INTERNATIONAL CODE COUNCIL

2009/2010 CODE DEVELOPMENT CYCLE

2009/2010 FINAL ACTION AGENDA FOR THE PROPOSED CHANGES TO THE 2009 EDITIONS OF THE

INTERNATIONAL BUILDING CODE®

FIGURE 1613.5(1)
MAXIMUM CONSIDERED EARTHQUAKE GROUND MOTION FOR THE CONTERMINOUS UNITED STATES OF
0.2 SEC SPECTRAL RESPONSE ACCELERATION (5% OF CRITICAL DAMPING), SITE CLASS B

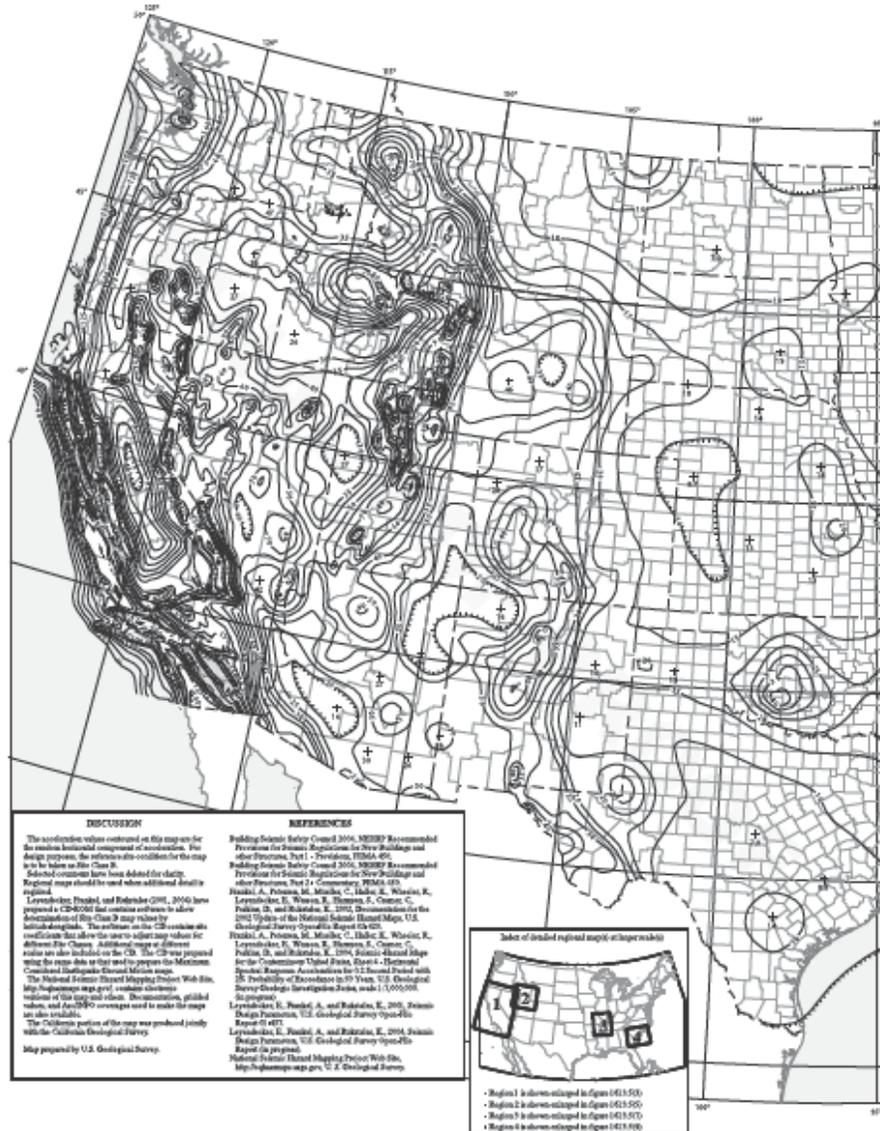
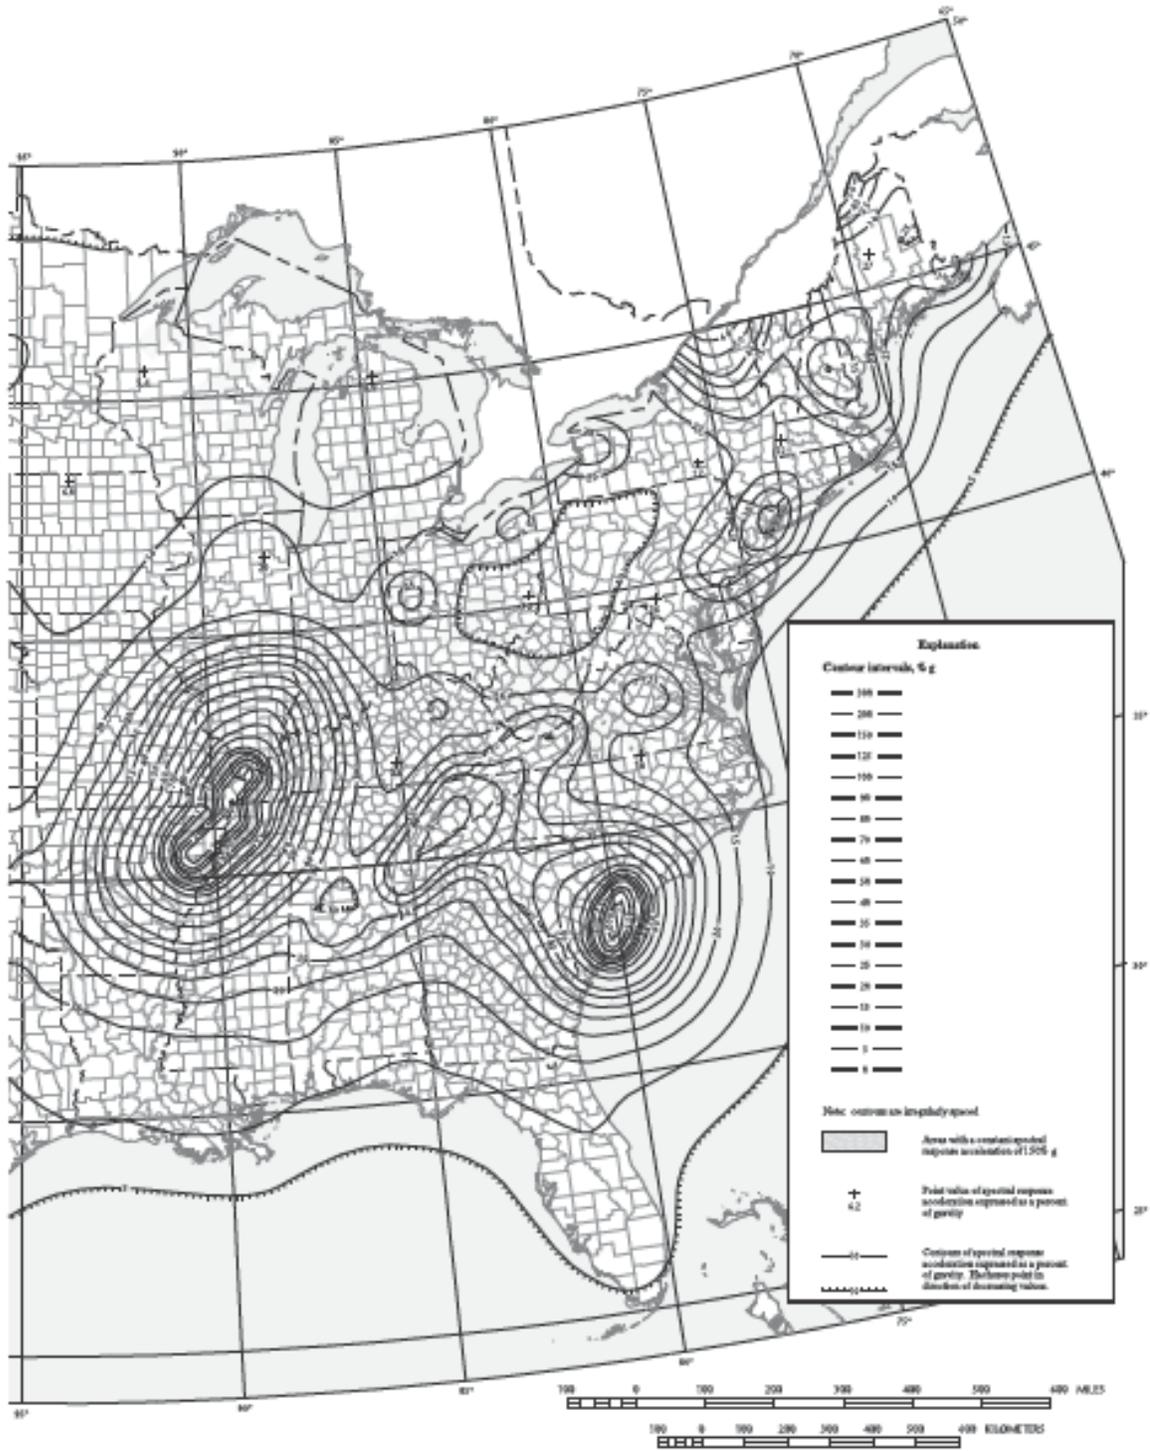
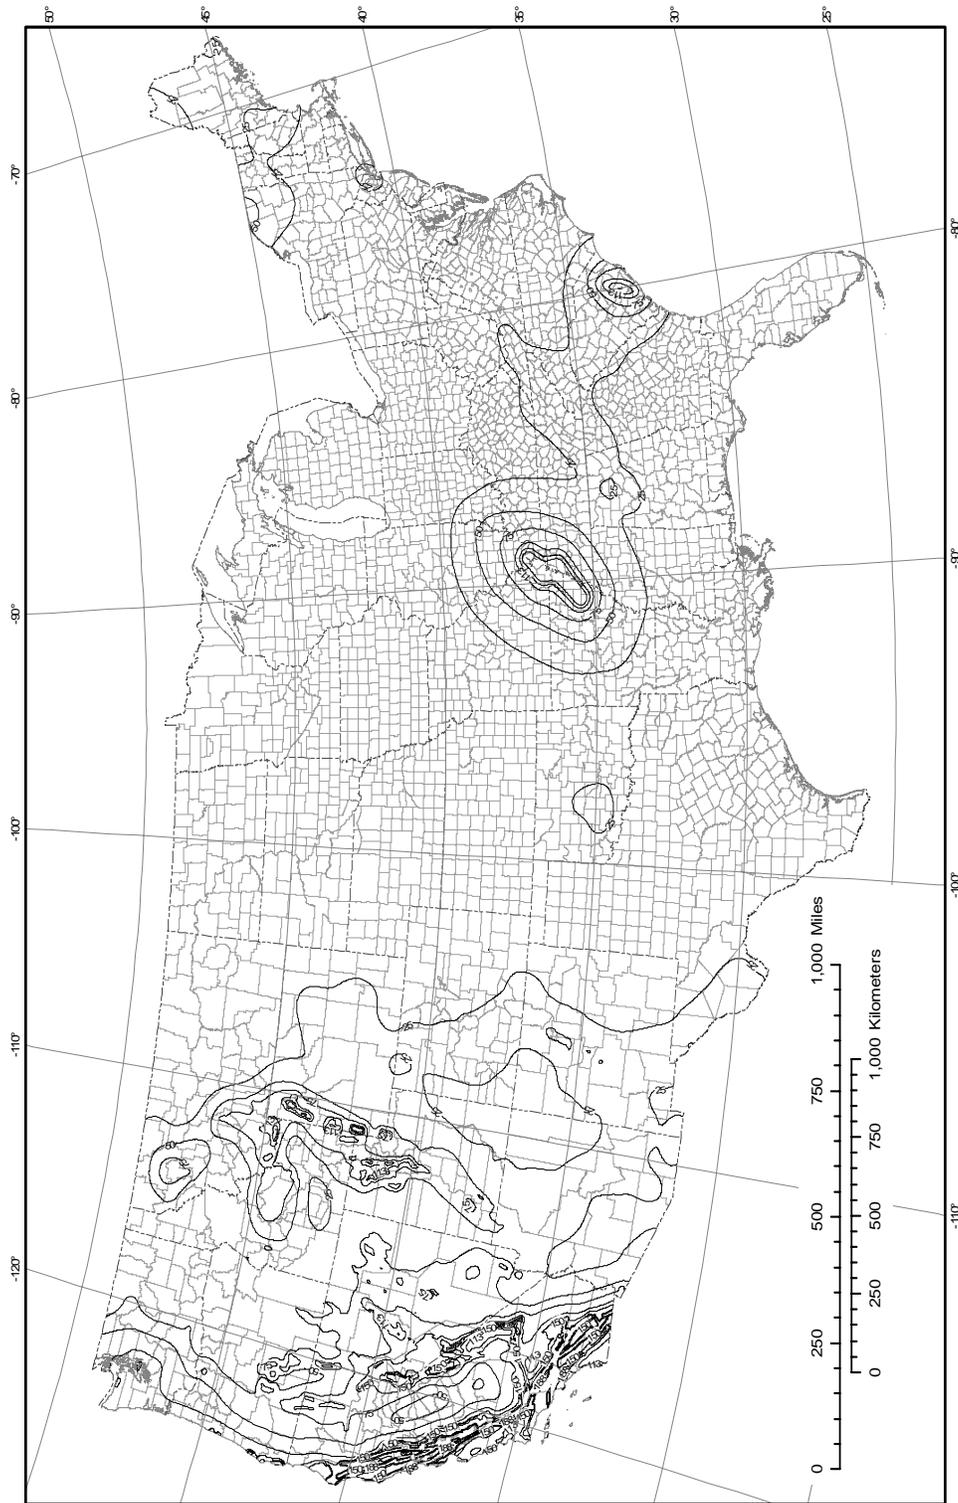
2. Delete and substitute as follows:
